# Product Change Notification

## 111865 - 00

**Change Notification #:** 111865 - 00  
**Change Title:** Intel® Desktop Board D2550MUD2 Boxed and Bulk  
Intel® Desktop Board D2700MUD Boxed and Bulk  
PCN 111865-00, Product Material  
Replace Clock Generator  
**Date of Publication:** November 09, 2012

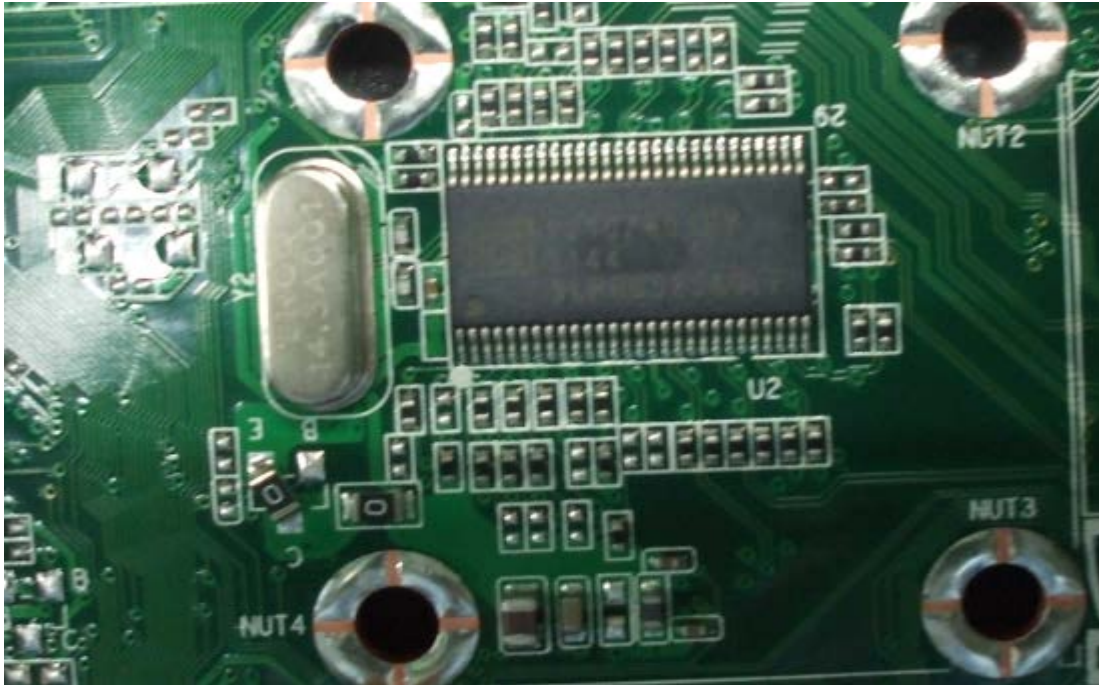
The clock generator chip will be changed from Silego (SLG505YC256CTTR) to IDT (9LPRS525AGLFT) in order to improve supply availability. There will be a change to some supporting components associated with the clock generator (remove R249, C111, R486 and Q21 and add 0 ohm on R486 and Q21).
